ADA Curb Ramp New Construction Inspection Form (Combination)

NW Curtis

NW Pacific

COMBINATION RAMP (C)

COMBINATION RAMP (C)

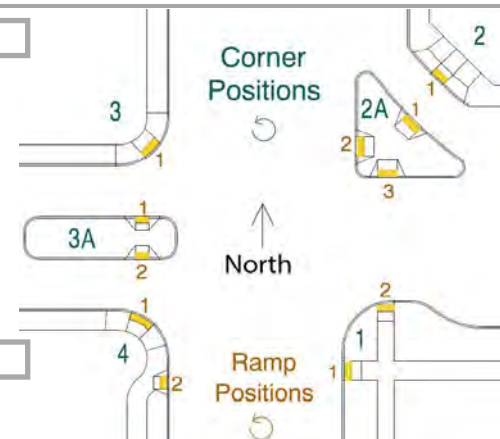
☒

☒

☒

☒

☒

Ramp run 3-crack in walking path
